Staff Report PC20-052-DP

Milhaus Multi-Family

Docket PC20-052-DP – Development Plan and Waiver – Milhaus Multi-Family

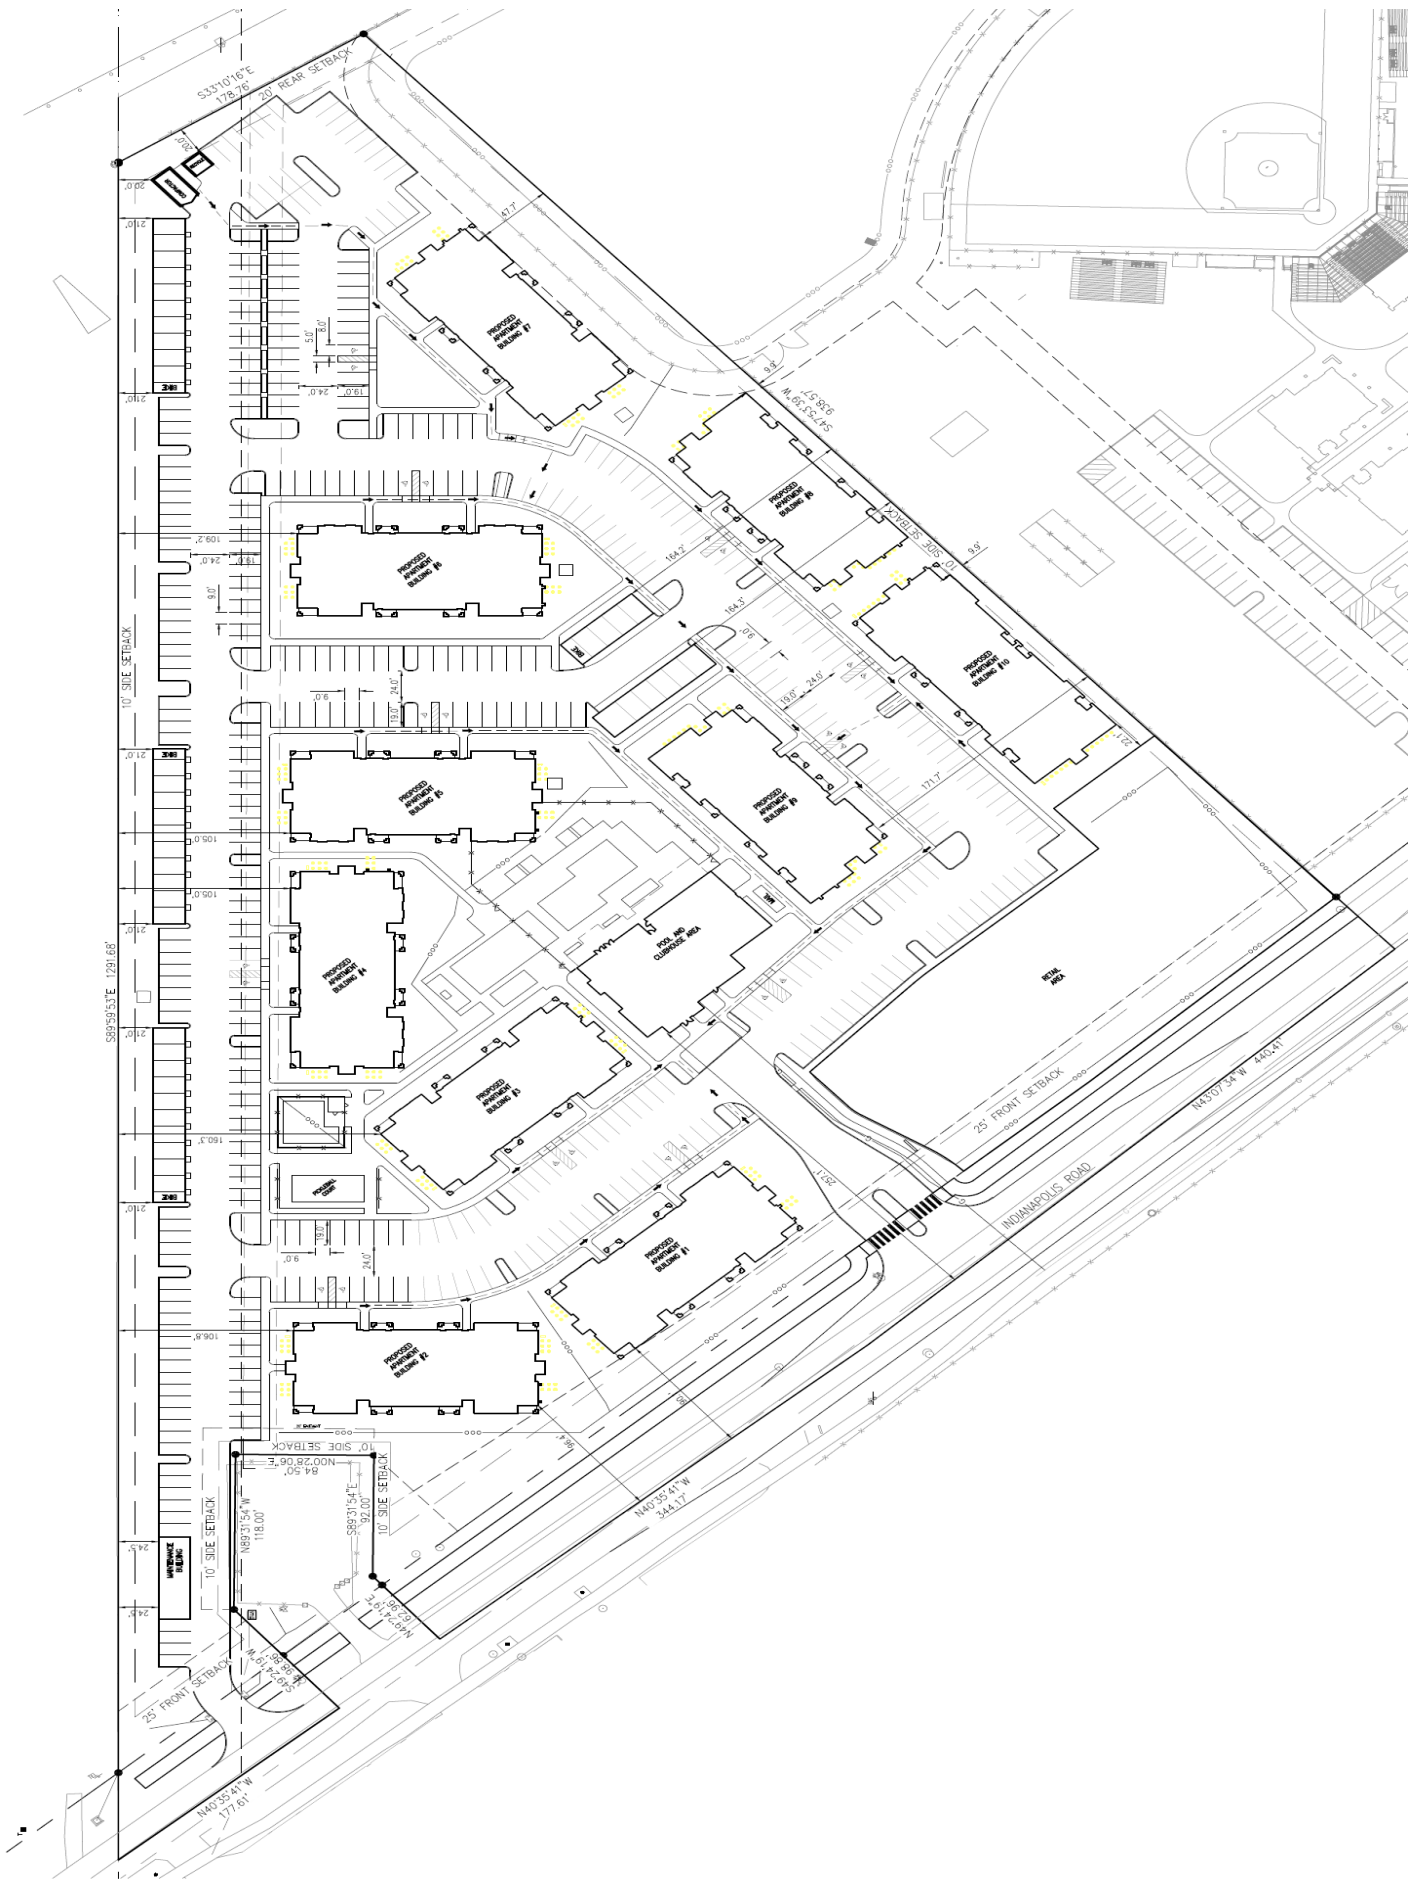
Based on the architectural standards of the I-65 South Corridor Overlay, the ordinance requires brick used to be a red color. The petitioner requests a waiver to use a red brick that is painted a steel color.

The Development Plan elevations propose approximately 50% of the exterior building to be covered in brick. Changing or maintain the brick color will not affect the integrity of the Development Plan. The brick color will not affect the use of the site.

The proposed building material is not appropriate for the surrounding area. The adjacent Little League Headquarters facility is using red brick consistent with the requirements of the I-65 South Corridor Overlay. A brick color other than red, would be out of character with the surrounding area and not appropriate for the site.

Section 3.1 A. of the UDO states the “purpose of the I-65 South Corridor Overlay District to preserve the aesthetic qualities of those bordering properties through: 1. The promotion of coordinated development in the I-65 South Corridor Overlay District; 2. The establishment of high standards for buildings, landscaping, and other improvements constructed on the properties within the I-65 South Corridor Overlay District which permit innovate site designs and at the same time encourage efficient land usage; and 3. The establishment of development requirements will encourage substantial capital investments for the development of those properties and promote the quality, scale, and character of development consistent with the I-65 Corridor’s existing and planned uses.” The requested waiver is in contradiction with the intent of the I-65 Corridor Overlay and will not promote a coordinate development by electing to use a different exterior building material than otherwise listed.

Staff is providing an unfavorable recommendation for the proposed Wavier. Staff finds by differing from the permitted list of materials, the development will be out of character with the surrounding area and will have a negative effect on creating the intended aesthetic or character of the area as intended by the I-65 South Corridor Overlay.
